**PLANNING COMMISSION
Meeting Agenda
Monday – May 23, 2011
7:00 PM - Regular Meeting
City Council Chambers – 155 NW 2nd Avenue**

Canby Police Facility - The applicant is requesting Site and Design Review approval to construct a new 25,300sf police facility and a 10,000sf daylight basement for future expansion. The site is 1175 NW 3rd Avenue. The lot is approx. 13.91 acres with 4.63 acres being disturbed. Zone: Light Industrial (M-1). **DR 11-02** Markus Mead, Associate Planner

**STAFF REPORT TO THE
PLANNING COMMISSION
FOR THE CITY OF CANBY, OREGON**

CASE NAME: Canby Police Station DR11-02

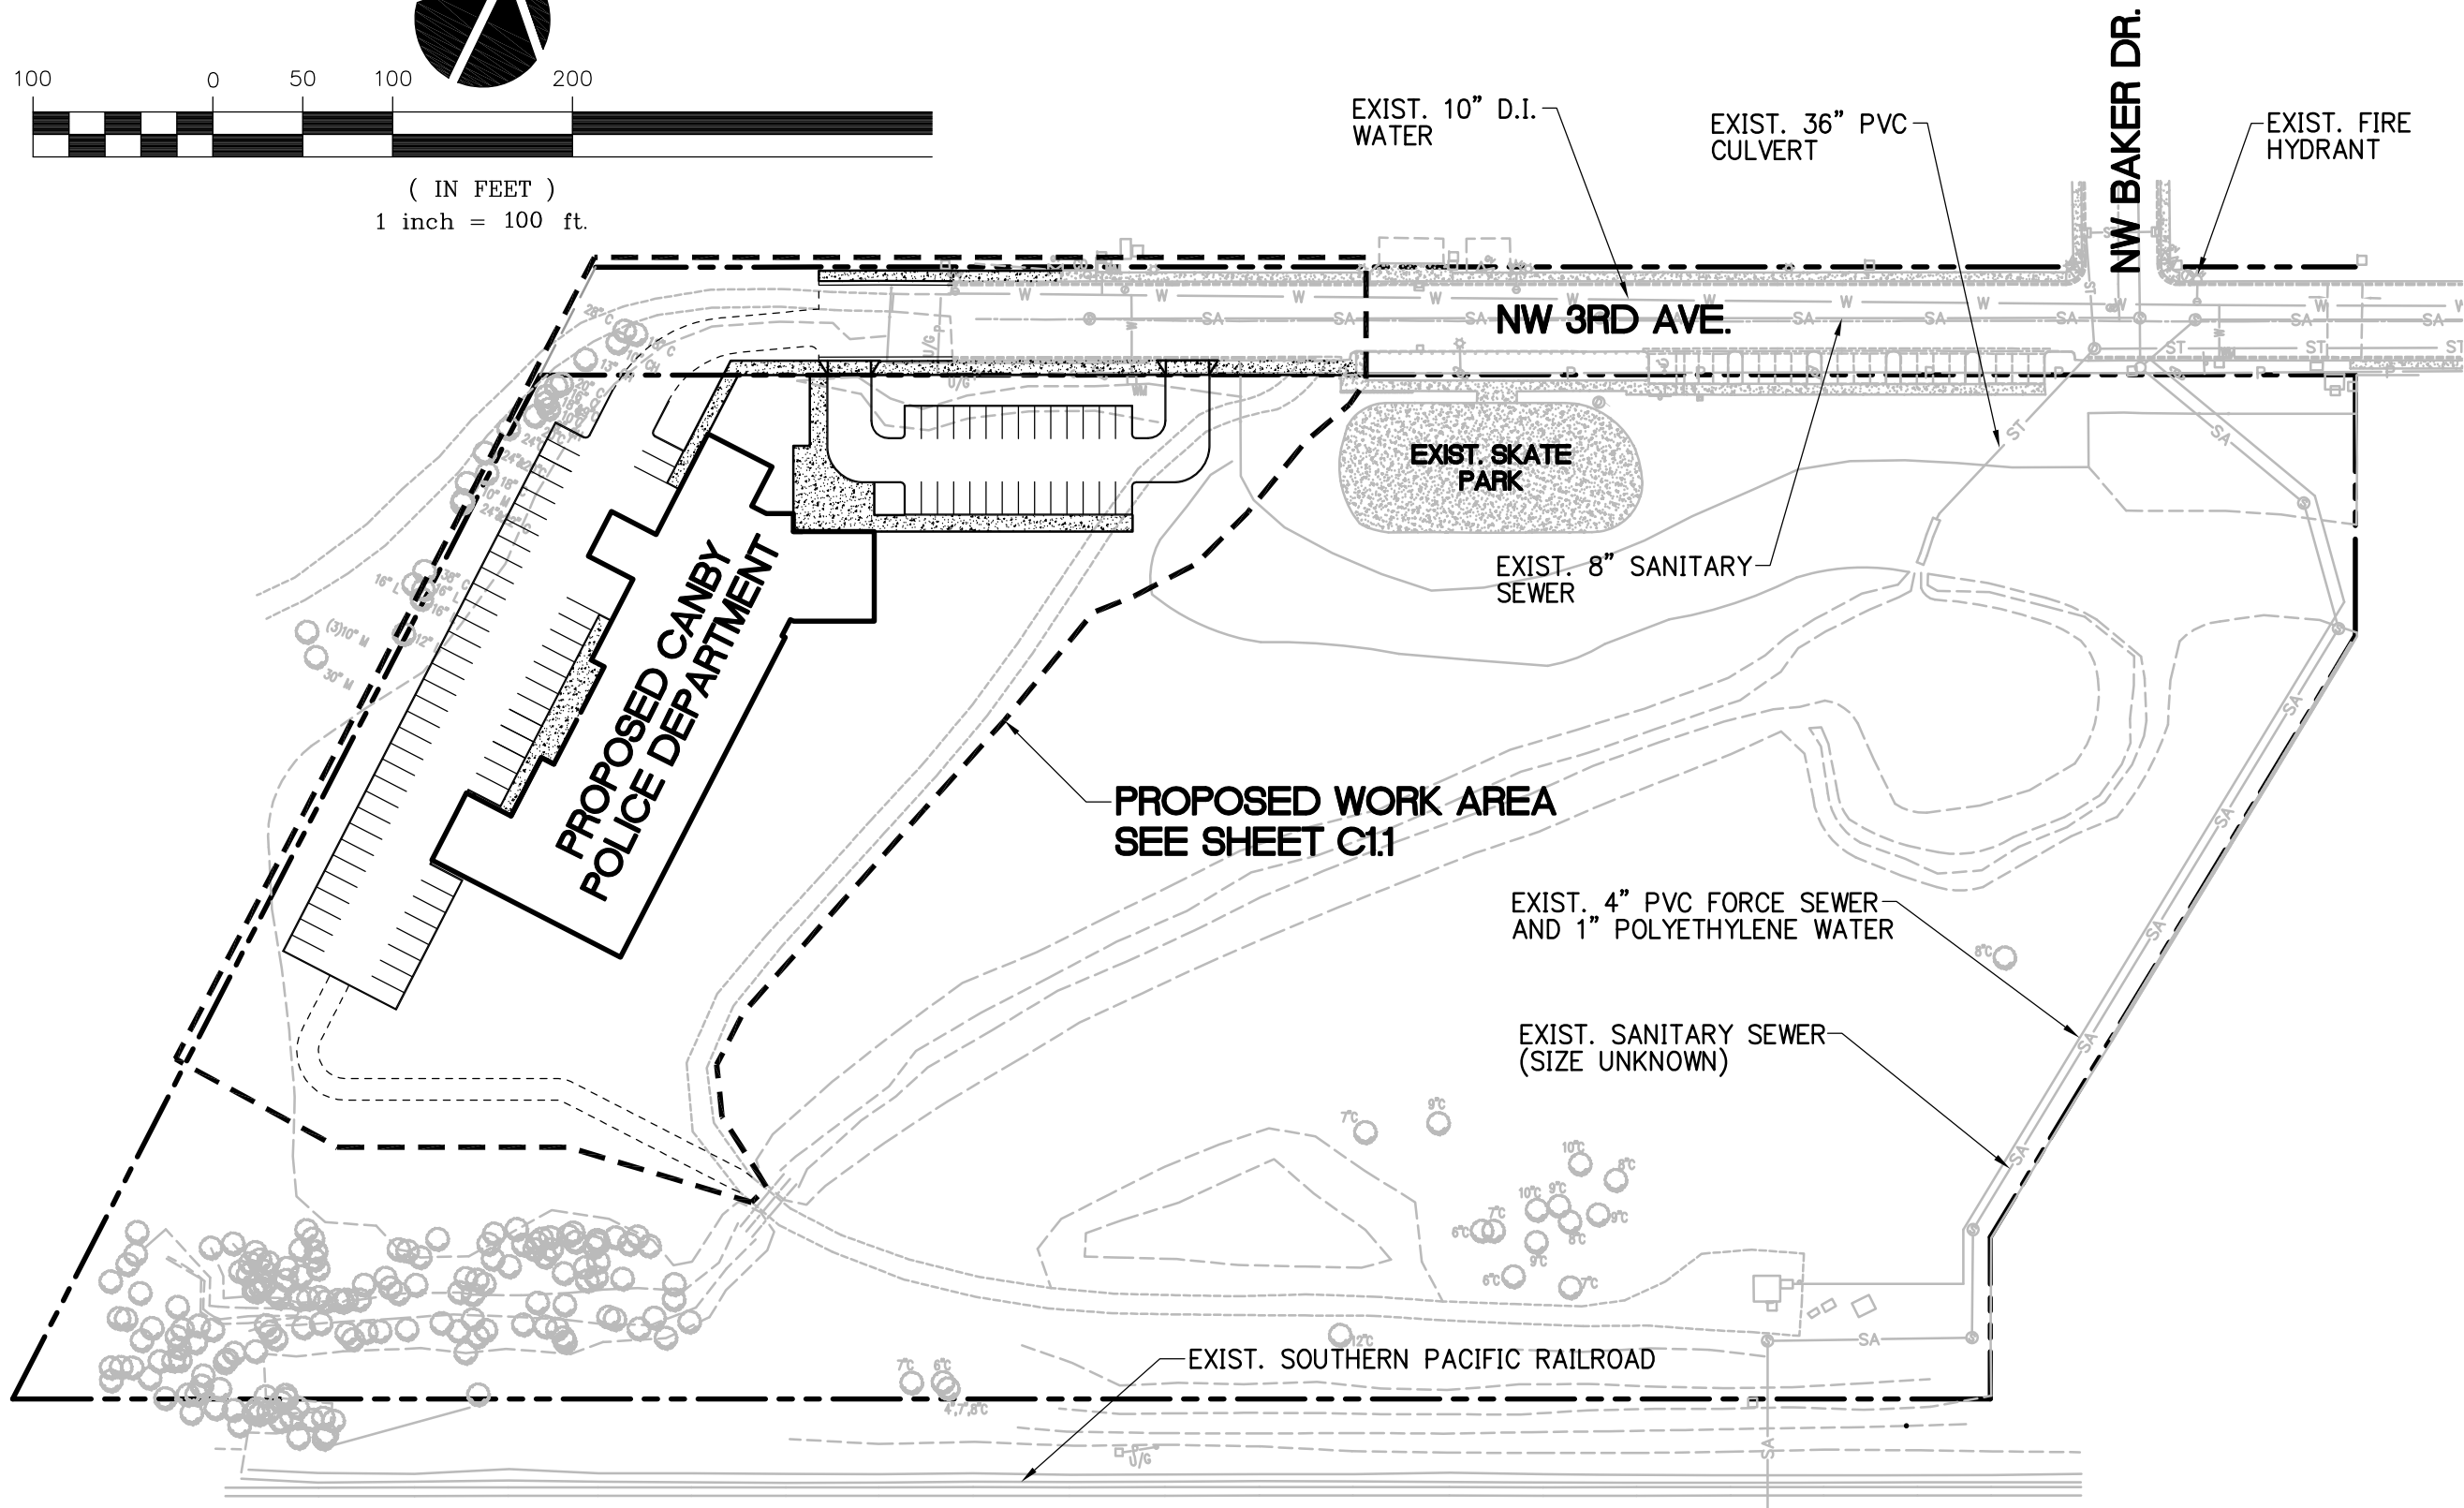
- Reduce through-traffic on N Cedar Street and NW 2nd Avenue by:
 - Install guide-signing to the police station that routes traffic on NW 3rd Avenue instead of NW 2nd Avenue.
 - Request that the police department works with employees to require commute trips and emergency response (when applicable) to use NW 3rd Avenue to/from reach N Elm Street.

If the guide-signing and employee education is effective, no further mitigation may be required. However, to provide adequate mitigation in-case the measures are not effective, the following additional measures are recommended:

- Collect fees equivalent to the design and construction of a traffic circle at N Cedar Street and NW 2nd Avenue
- Conduct traffic counts 6-months after occupancy of the site to determine if additional mitigation is required
- If additional mitigation is required, engage the residents along N Cedar Street and NW 2nd Avenue to determine appropriate mitigation for the through-trip impacts. Construct the mitigation with the fees collected from the applicant.
- If additional mitigation measures are not required and no complaints are received after a period of 2 years, refund the mitigation fees to the applicant.
